ATTN: Document Control Desk
U. S. Nuclear Regulatory Commission
Washington, DC 20555-0001**SUBJECT:****Beaver Valley Power Station, Unit No. 2**
Docket No. 50-412, License No. NPF-73
Supplemental Information for Beaver Valley Power Station Unit 2 Spent Fuel Pool
Rerack License Amendment Request (TAC No. ME1079)

February 28, 2011, March 9, 2011, and March 11, 2011
Supplemental Information
Page 1 of 5

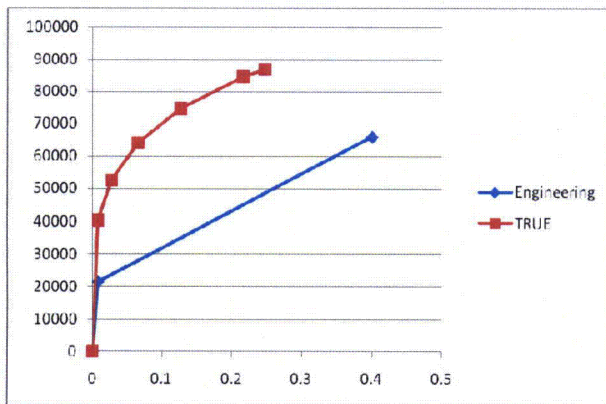
2. Given that RAI 17 was focused on the evaluation performed for the shallow drop scenario, additional clarification regarding the use of stress-strain curve in the deep drop accident scenario is necessary.

The engineering stress-strain curve was used to represent the welds for the deep drop accident. This curve is conservative for this application. A comparison was made between the engineering stress-strain curve used for the deep drop analysis versus the true stress-strain curve used for the shallow drop analysis. For the deep drop analysis (which used engineering stress-strain), the failure strain limit is input as 0.4. For the shallow drop analysis (which used true stress-strain), the failure strain limit is

input as 0.2465 for welds. The area under each curve represents the strain energy that can be absorbed prior to failure. A comparison of the curves is provided below. The strain energy determined from the engineering stress-strain curve is nearly equal to that of the true stress-strain curve, with the true-stress strain curve having slightly more capacity.

Strain Energy True - 17289 Lbf-in/in ³ Engr. - 17247 Lbf-in/in ³
--
